<b>A4</b>	PROJECT	ADKINS CUSTOM
	APPROVED	I.M.
DRAWN	S.S.	SCALE AS NOTED
FILE		DATE JAN 2021

TITLE MAIN FLOOR PLAN

<b>A5</b>	PROJECT	ADKINS CUSTOM
	APPROVED	I.M.
DRAWN	S.S.	SCALE AS NOTED
FILE		DATE JAN 2021

TITLE UPPER FLOOR PLAN

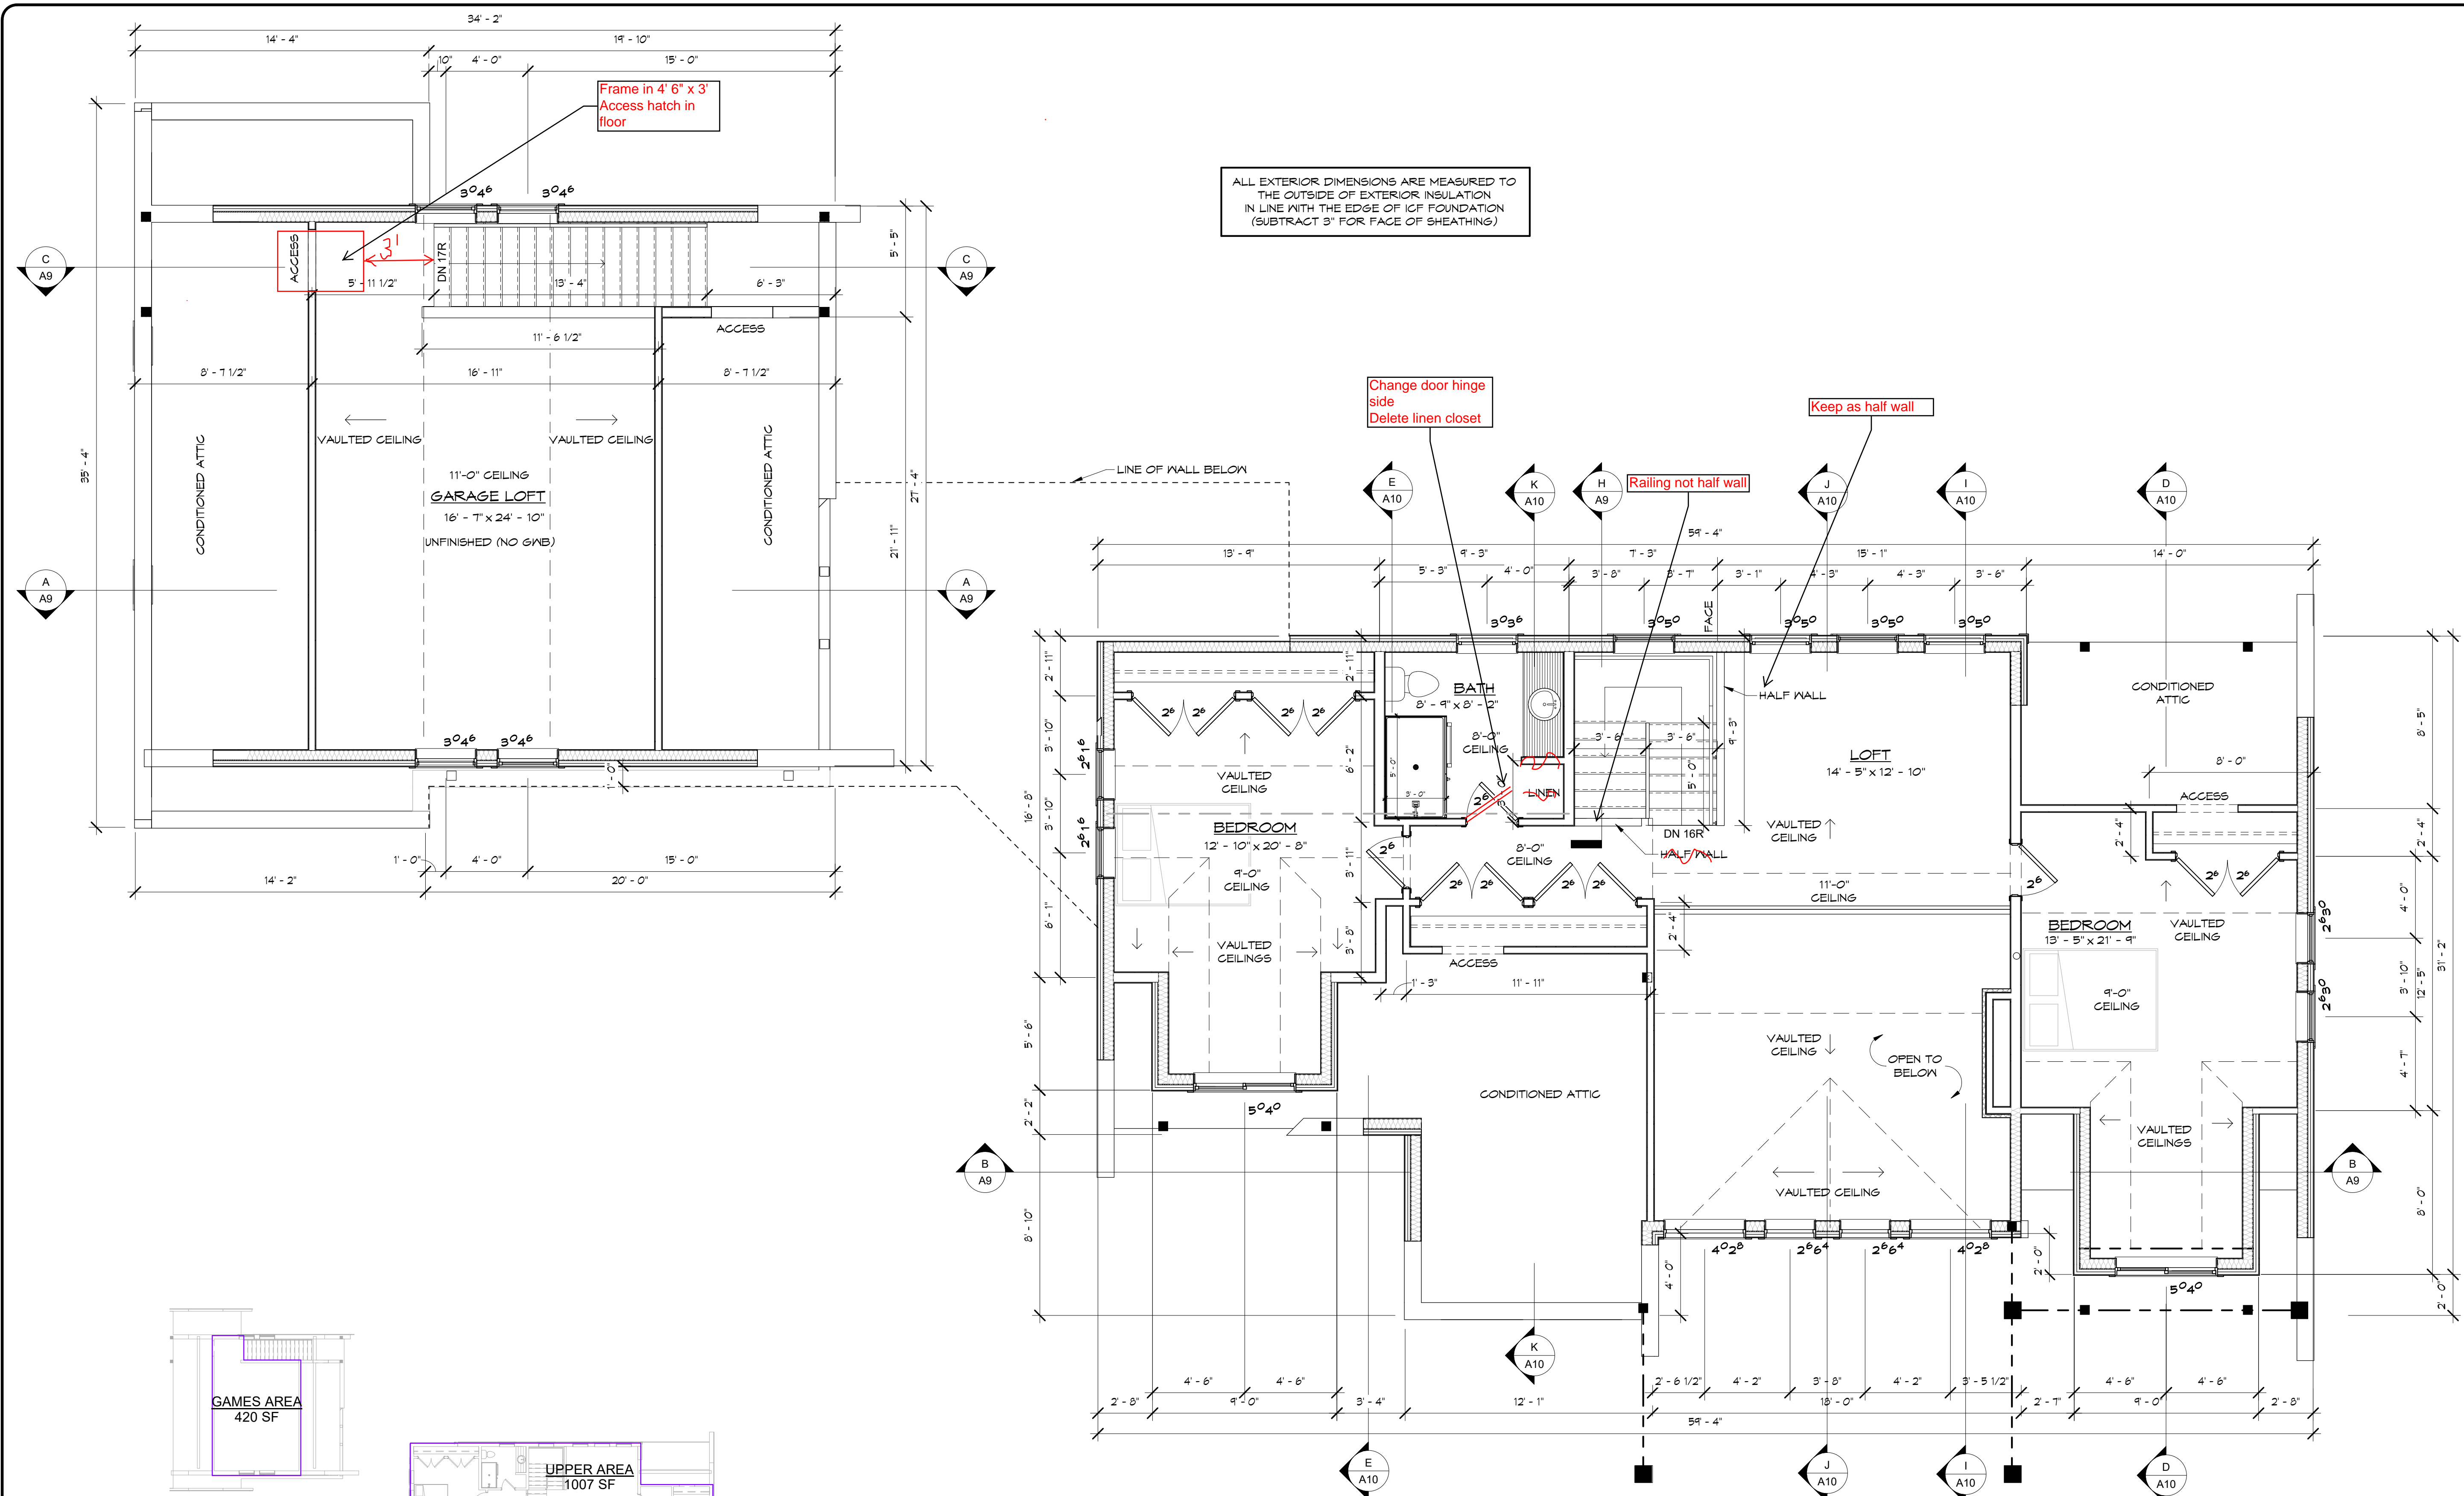
Frame in 4' 6" x 3' Access hatch in floor

Change door hinge side  
Delete linen closet

Keep as half wall

Railing not half wall
